A.D. Ybarra; No. 4; W. H. P. Report No 5706

Amended part of Midship section.

RAYLTON DIXON, & CO.
IRON SHIPBUILDERS
No 4343
DATE 10th August 1882
CLEVELAND DOCKYARD
MIDDLESBROUGH-ON-TEES

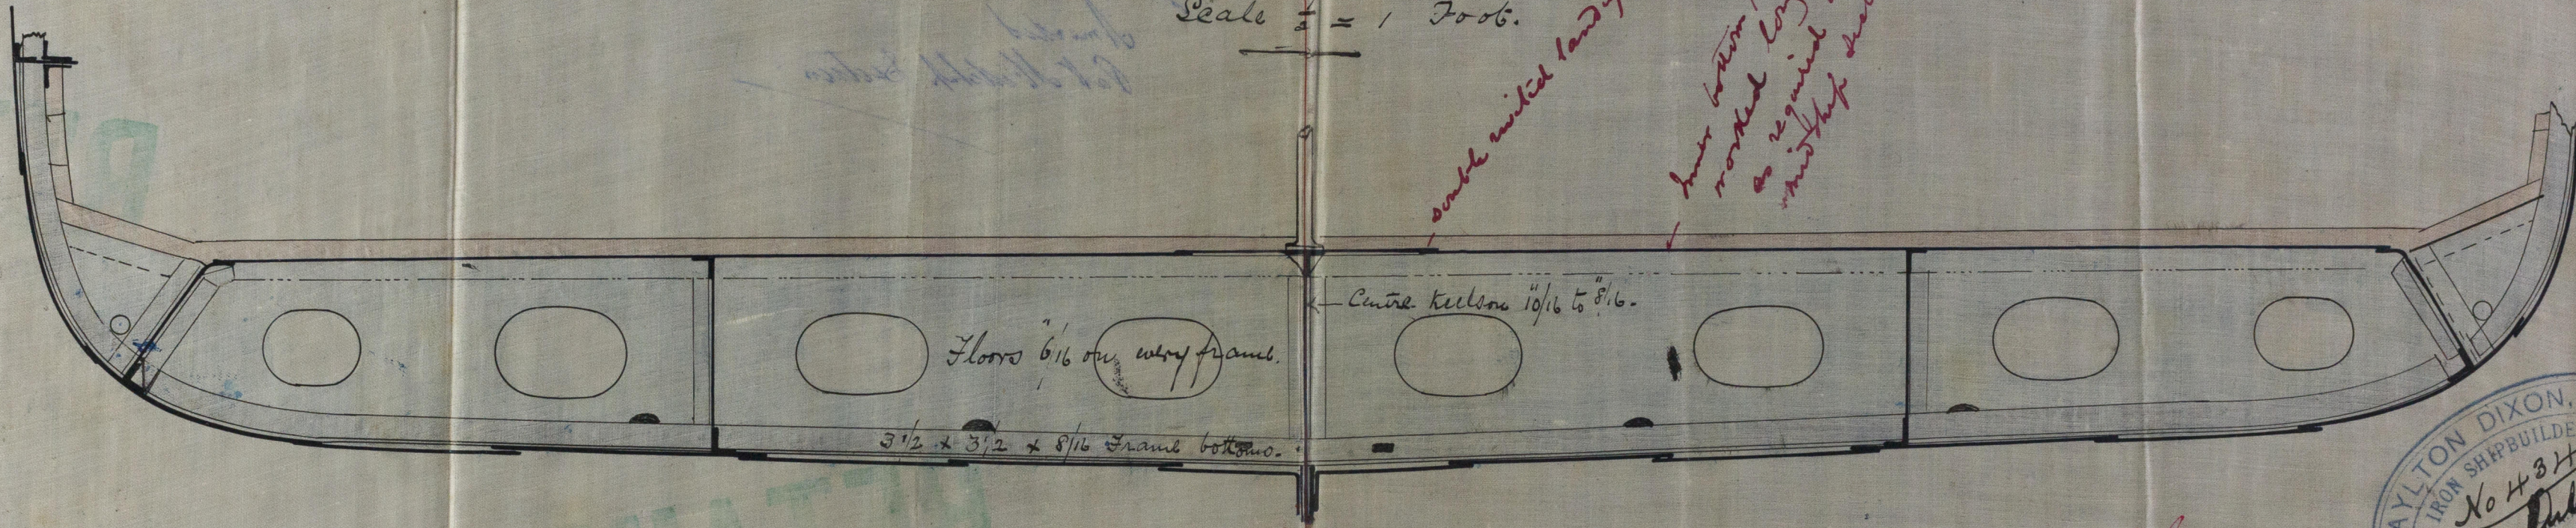
double mild landing edge
have bottom plating
worked longitudinally
as required in approved
midship section
